State of California  
Department of Fish and Wildlife

## Memorandum

**Subject:** **COMMENTS ON DRAFT WATER QUALITY CERTIFICATION, SOUTH FEATHER WATER AND POWER AGENCY'S SOUTH FEATHER POWER PROJECT, FEDERAL ENERGY REGULATORY COMMISSION PROJECT NO. 2088**

Subject: COMMENTS ON THE INITIAL STUDY/ENVIRONMENTAL CHECKLIST AND PROPOSED MITIGATED NEGATIVE DECLARATION FOR LICENSING OF THE SOUTH FEATHER POWER PROJECT (FERC PROJECT NO. 2088)

Figure 1. Water in Little Grass Valley Dam reach at three monitoring sites rarely reaches temperatures adequate for healthy rainbow trout growth and development.

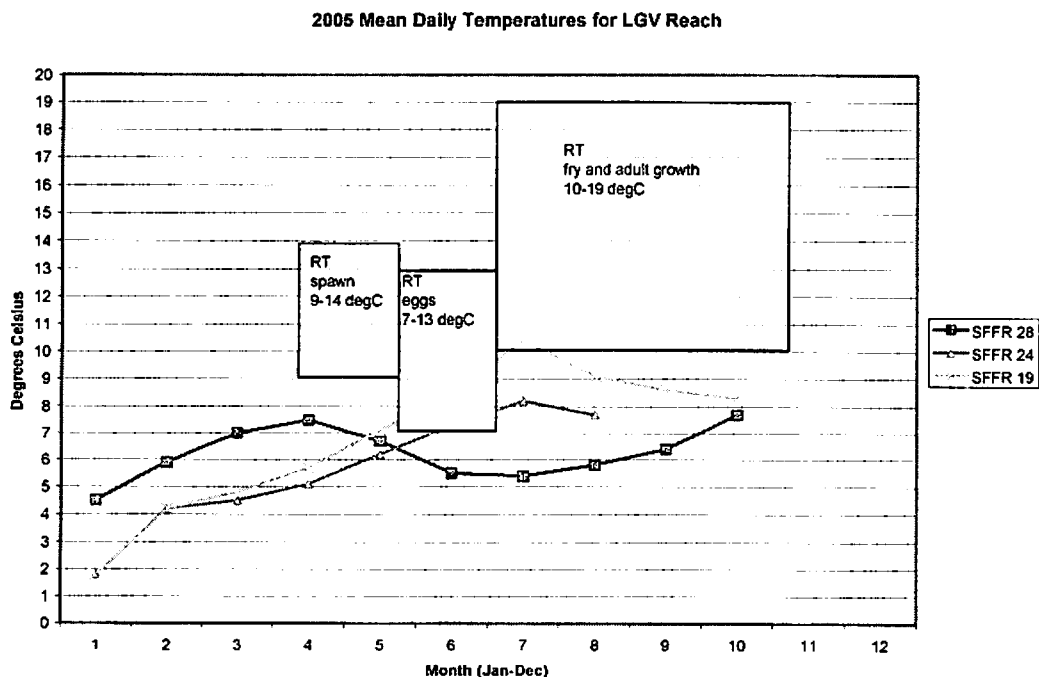
In Section 5.4.9 of the IS, in response to Question F asking whether the project has the ability to otherwise substantially degrade water quality; the licensee states that the project has a "Less than Significant Impact." Water temperature in Little Grass Valley reach remains unseasonably cold all year. Rainbow trout (RT) are the native coldwater fish species for the project area and a valuable indicator of habitat quality for a host of aquatic organisms in Sierra Nevada westslope streams. Rainbow trout biomass and density estimates in Little Grass Valley reach are depressed when compared to other Sierran streams. Rainbow trout require a water temperature of 10-19°C for growth, with optimum temperatures for growth ranging from 14-19°C (Moyle 2002, Bell 1980, Myrich and Cech 2000). Due to the low level release from Little Grass Valley reservoir, water temperature in the bypass reach rarely exceeds 10°C and may not adequately support RT growth and recruitment (Figure 1).

Such low temperatures may delay spawning and reduce egg development (Moyle 2002, Bell 1980). Smaller-sized fish have lower winter survival (Overton and McDonald 1998). Low water temperature during the critical period for growth is likely a contributing factor to low RT biomass. The licensee states that implementation of the Water Temperature Monitoring Plan will ensure that there is "Less than Significant Impact". There are indications that the current low water temperature may impair the quality of rainbow trout habitat. Monitoring alone does not provide protection of aquatic habitat.

Figure 2. Difference between Temperature of Water Released from KRPH and Water in Diversion Pool Downstream of Hyatt Powerhouse

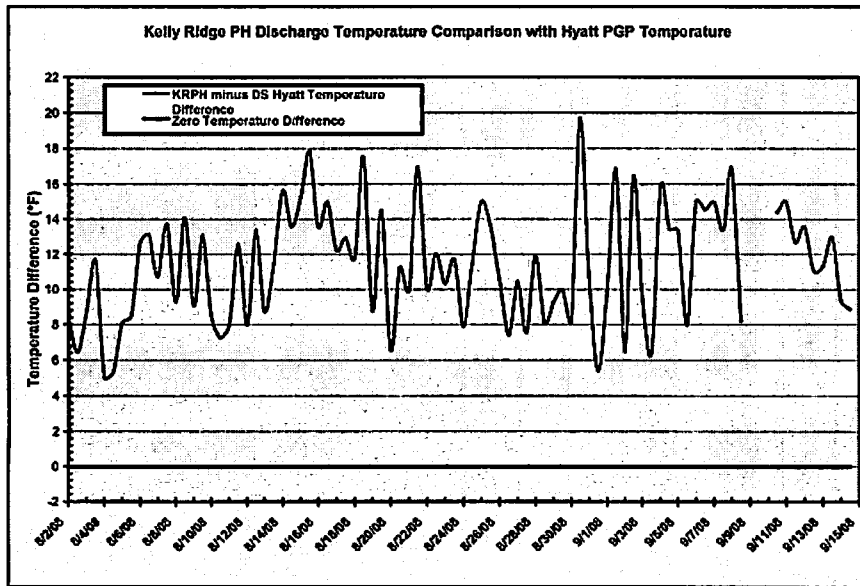
The statement above that the "large storage reservoir dwarf the SFWPA project making active coordination of the projects unnecessary" is misleading. Under certain regularly occurring conditions, warm water released from the SFWPA project from Kelly Ridge Powerhouse (KRP) impact the water temperatures in the diversion pool downstream of Lake Oroville and force the California Department of Water Resources (DWR) to coordinate projects by making higher releases from storage or other operational changes at Lake Oroville, to meet downstream hatchery and instream temperature objectives. This may represent a significant impact as temperatures that are too warm can alter the natural production of populations of Endangered Species Act (ESA) listed and non-listed native anadromous species in the Lower Feather River.

Water from the KRP is released into the diversion pool below Lake Oroville approximately 1000 feet downstream from the location where DWR's Hyatt Power Plant releases water to the Feather River. Water from the diversion pool is then either released into the Low Flow Channel section of the Feather River or diverted through DWR's Thermalito system and eventually released into the Feather River from the Thermalito Afterbay. The intake for water supply to the Feather River Hatchery is collected at the diversion dam. While the releases from Hyatt are typically much higher than those from KRP, particularly during off-peak hours, Hyatt Powerhouse is often shut down or releasing water into the diversion pool by DWR only for the purpose of meeting instream flow and hatchery flow requirements. Under these conditions, the warmer water from KRP does impact water temperatures in the Thermalito Diversion Pool and at points downstream, including the Feather River Fish Hatchery.

The plots above illustrate the conditions which occurred in the summer of 2008, where temperatures discharged from KRPH were as much as 20°F warmer than temperatures in the Diversion Pool downstream from DWR's Hyatt Powerhouse. Additionally they show that diversion pool temperatures were heated as much as 12°F by the addition of flow from KRPH.

Figure 3. Plot showing Temperature (°F) of Water Released from KRPH, Water Downstream of Hyatt Powerplant yet Upstream of KRPH, Water Released from KRPH, and Water Downstream of KRPH.

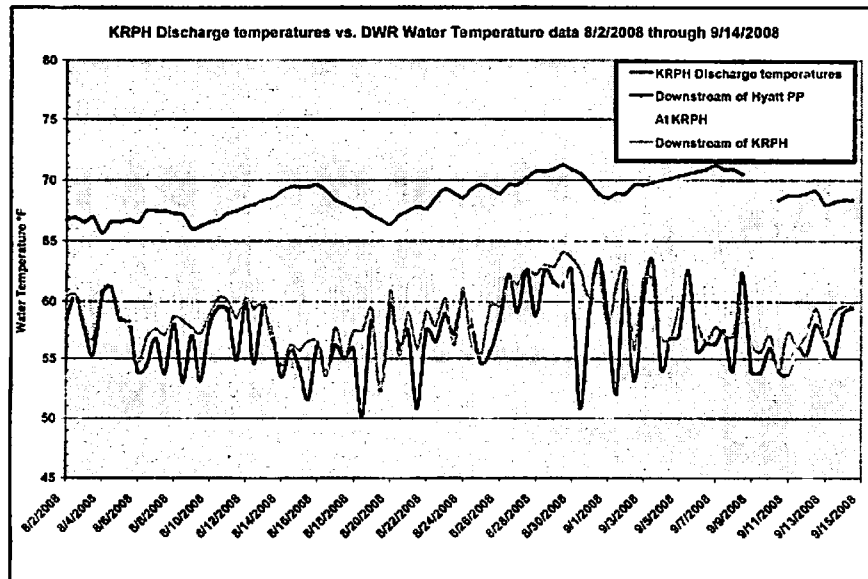
Furthermore, it is our understanding that under current conditions these projects are informally coordinated. DWR and SFWPA have both stated that DWR has in the past called upon SFWPA to curtail releases from KRPH and has subsequently reimbursed SFWPA for lost generation at KRPH. Although this may not be represented in a formal agreement between licensees, it certainly demonstrates that under certain circumstances the two projects are coordinated. The Department recommends that SFWPA acknowledge that their releases from KRPH have at least a potentially significant impact on ESA species, and should be further examined in the licensees CEQA analysis.
